May 28, 2013

Kraig Schultz  
Michigan Safe Energy Future (South Haven)  
11919 Mill Lane  
Grand Haven, MI 49417

You raised issues regarding the status of embrittlement testing, plant improvements, decommissioning funds and aging structures at nuclear power plants. In the enclosure, I have provided specific responses to the issues you raised.

## Responses to Questions and Concerns Raised in Letter Sent to the NRC by Mr. Kraig Schultz of Grand Haven Michigan

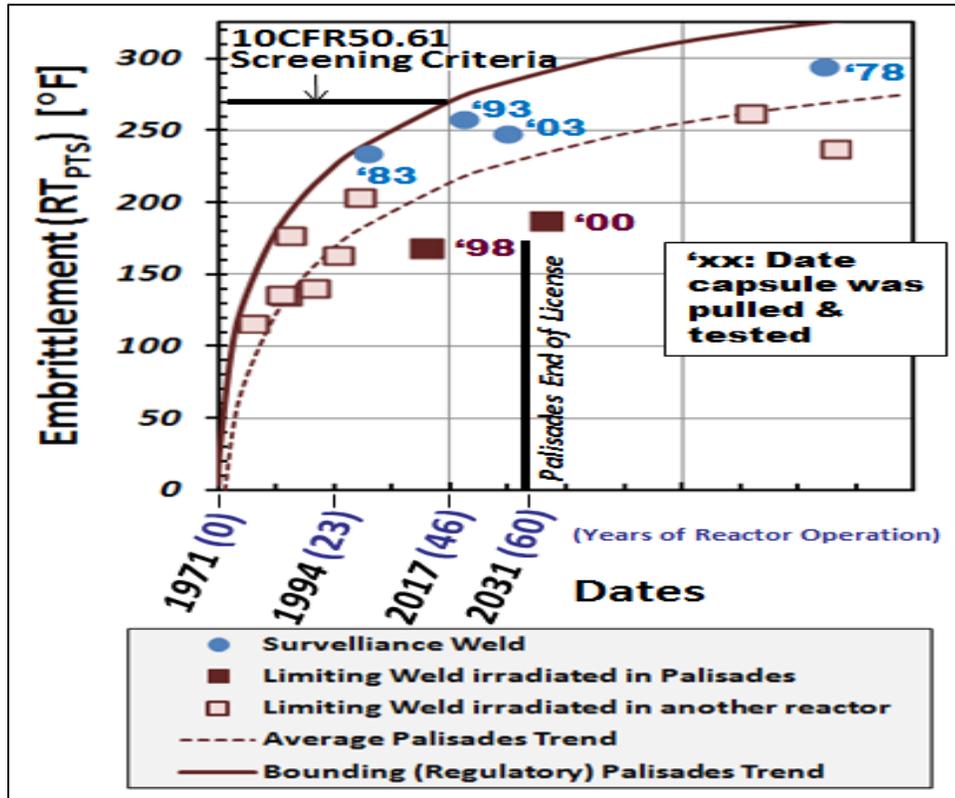
*c. Please provide us with a plot of the prediction model that shows actual data points taken during Palisades operating history.*

The plot requested is provided below. The plot, which was used as part of the end-of-cycle public meeting held on April 2, 2013, (see ADAMS ML13093A191) shows the variation of the embrittlement reference temperature ( $RT_{PTS}$ ) with years of

radiation exposure. This reference temperature the NRC uses to quantitatively assess brittleness can roughly be described as the temperature below which the material transitions from ductile to brittle behavior during a pressurized thermal shock (PTS) event. The higher the temperature corresponds to the higher the temperature at which the material transitions from brittle to ductile behavior and thus the higher the embrittlement.

Data from the surveillance capsules (squares and circles) are shown for the Palisades surveillance weld as well as for the weld in the Palisades vessel (labeled “limiting weld” on the plot), which have similar chemical composition. The plot shows that these measurements agree well with the NRC’s predictive formula and trend for Palisades from Regulatory Guide 1.99 (dashed curve), and are all over-estimated by the Regulatory Guide 1.99 bounding prediction (solid curve). Beyond the data irradiated in Palisades, information is also available from surveillance programs conducted in the H.B. Robinson and Indian Point reactor pressure vessels; these data appear as lightly filled squares. The plot demonstrates that surveillance data are already available for levels of radiation exposure far in excess of that which the Palisades vessel will reach when its license expires in the year 2031.

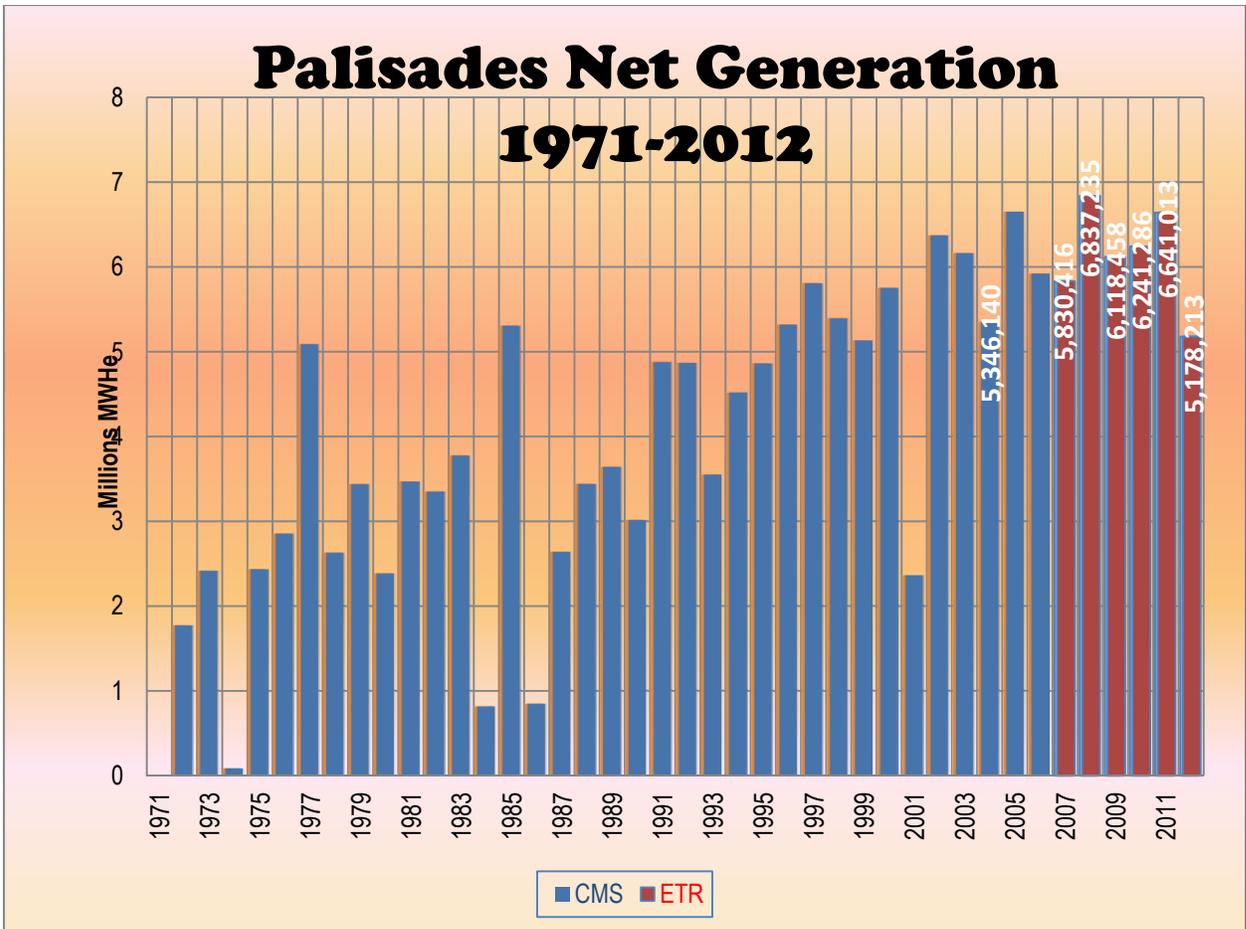
- c. *Is there a chart or graph that indicates how Palisades has performed over its entire 42 year lifespan for reliability? Has Palisades always been this bad, or is it getting worse?*

The following graph was provided by the licensee and it shows Palisades' net power generation from 1971-2012.

The blue (1971 – 2006) indicates power generation during the time that Palisades was owned by CMS Enterprise/Consumers Energy (CMS) and the red (2007 – 2011) indicates power generation when Entergy Nuclear Operations, Inc. (ETR) owned Palisades. As can be seen in this graph reliability has improved over time, although in 2012 net generation went down due to a planned refueling outage and several issues discussed previously.
